Subject: On-Call Asbestos, Lead, Air Quality & Demolition Compliance  
Agreement No. 8.07-01 (18)  
HazMat Inspection – Signage Replacement, Route 9, 15 & SR571 Connector, Cromwell & Berlin, CT  
ConnDOT Assignment No. 519-5849  
ConnDOT Project No. 7-189  
TRC Project No. 289951.5849.0710

**Subject:** Preliminary Design Review Request  
Project No. 0007-0189  
Replacement of Existing Signing on Routes 9  
(MP 24.65 to MP 34.48), 5/15 (MP 68.02 to  
73.40), & SR 571 (MP 00.00 to 01.25)  
Towns of Cromwell and Berlin  
**Date:** October 22, 2018

## PROJECT 7-189 ROUTE 9, 15, & SR 571 HIGHWAY RESIGNING

## Plans For REPLACEMENT OF HIGHWAY SIGNING ON ROUTE 9, 15, & SR 571 CONNECTOR

DRAWING NO.  
**TR-13**

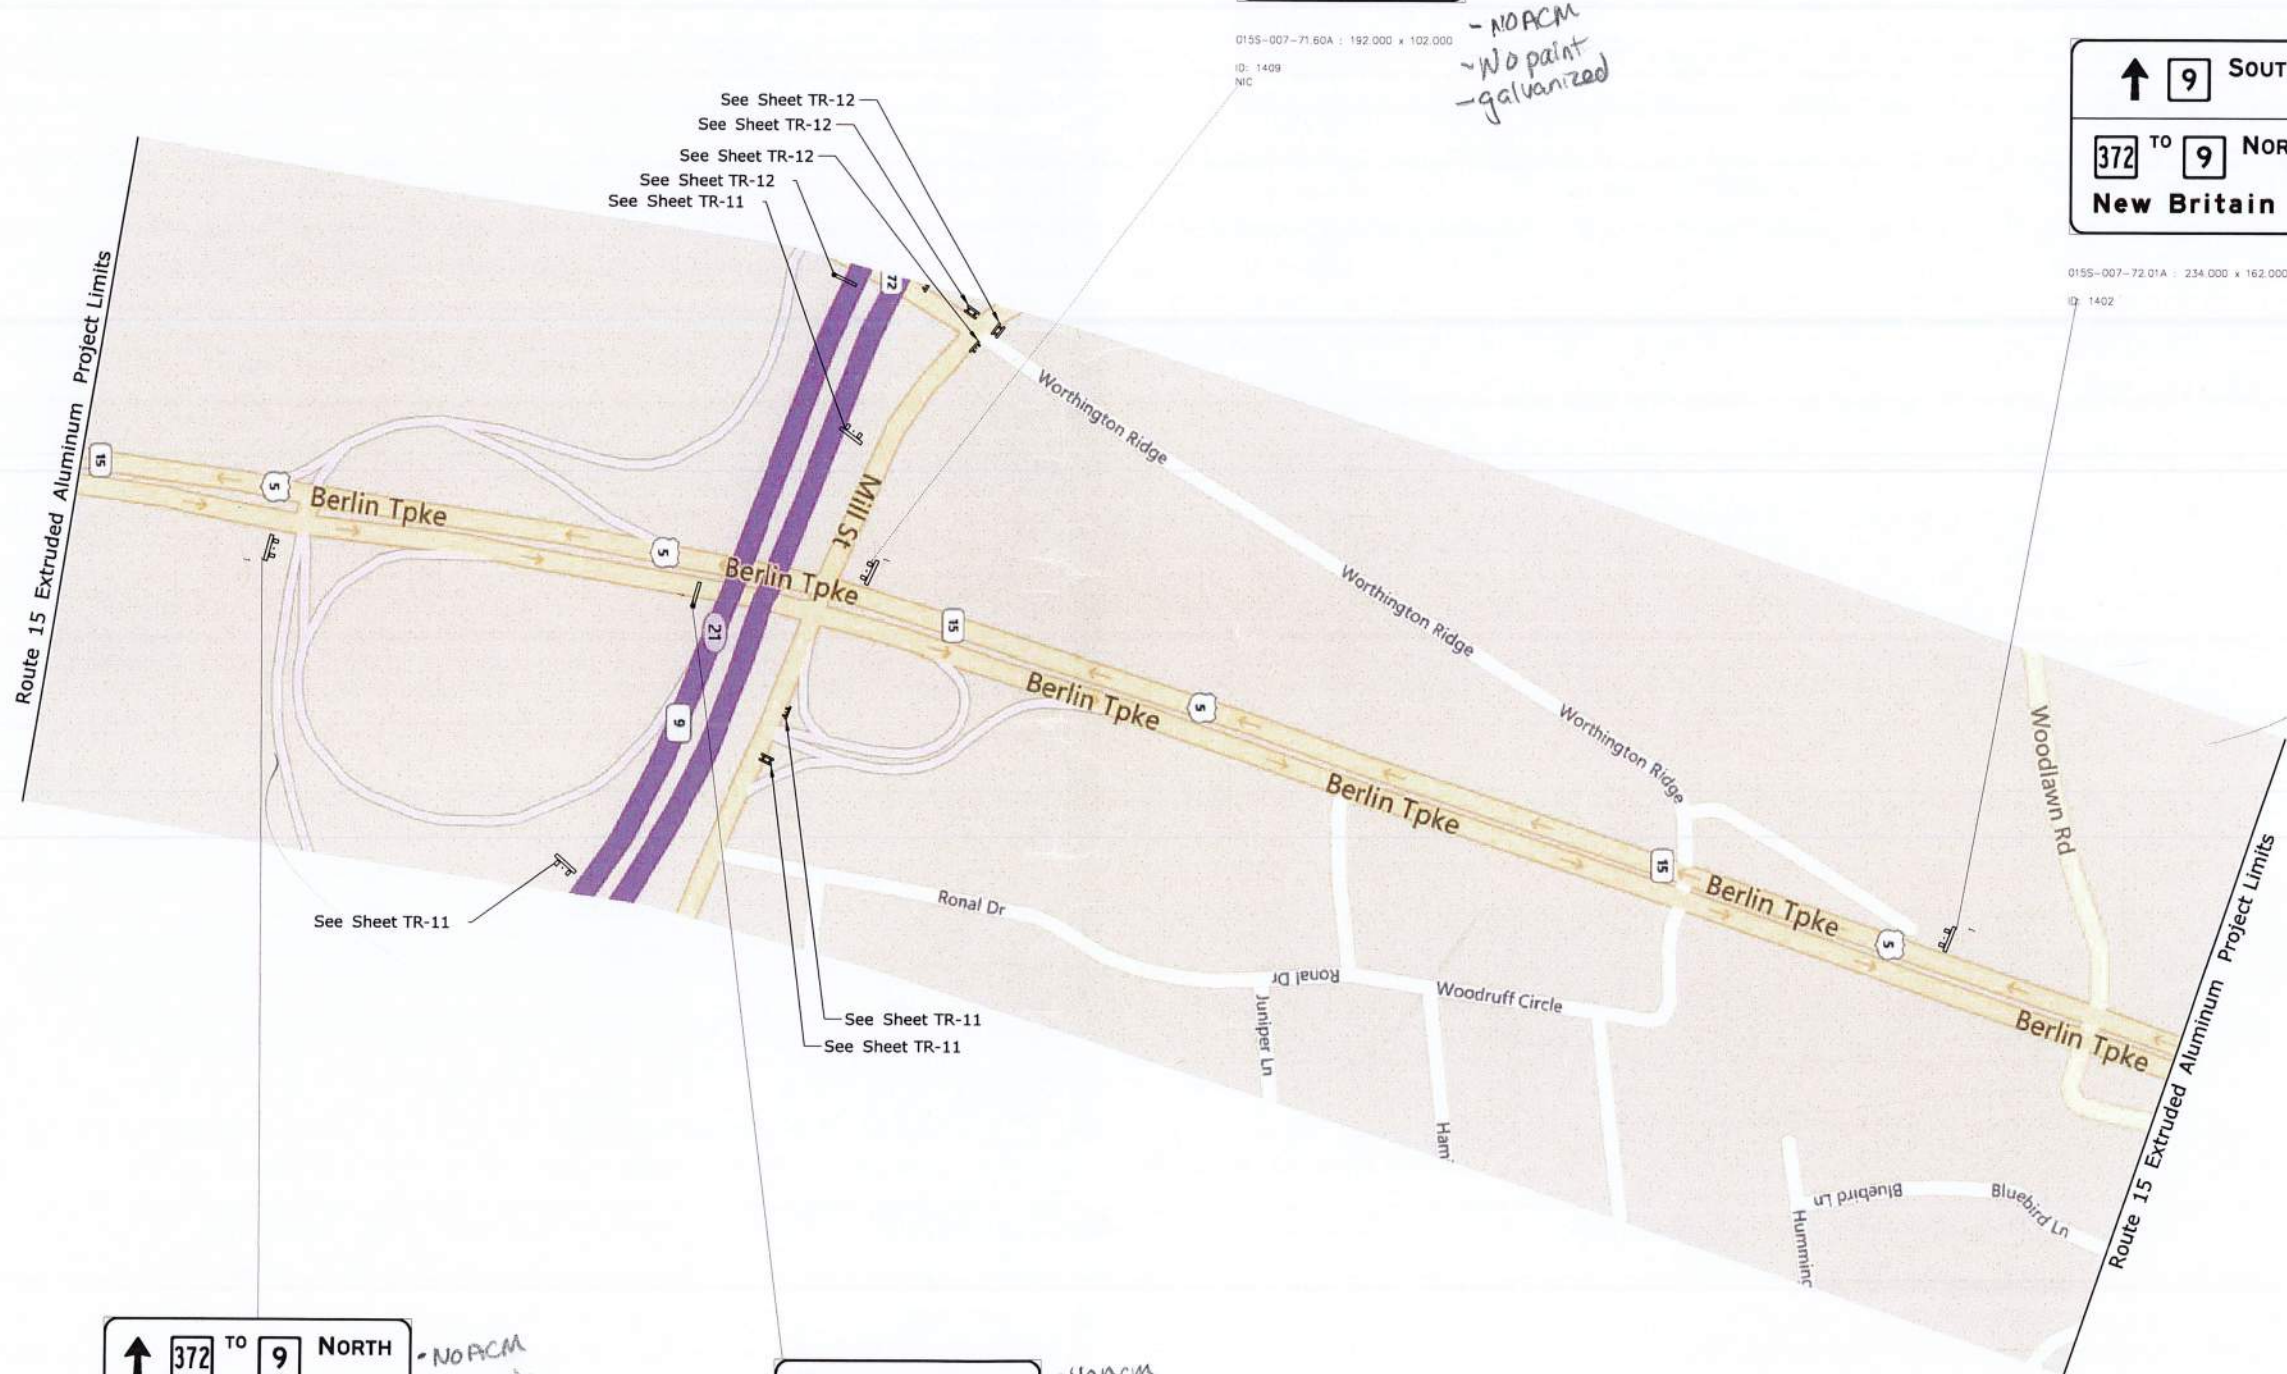
Will Drawings be included in the next submission extending beyond match to the Project Limits.  
Typical Comment.

- No paint  
- NO ACM  
- galvanized

0155-007-71.60A : 192,000 x 102,000  
ID: 1409  
NIC  
- NO ACM  
- No paint  
- galvanized
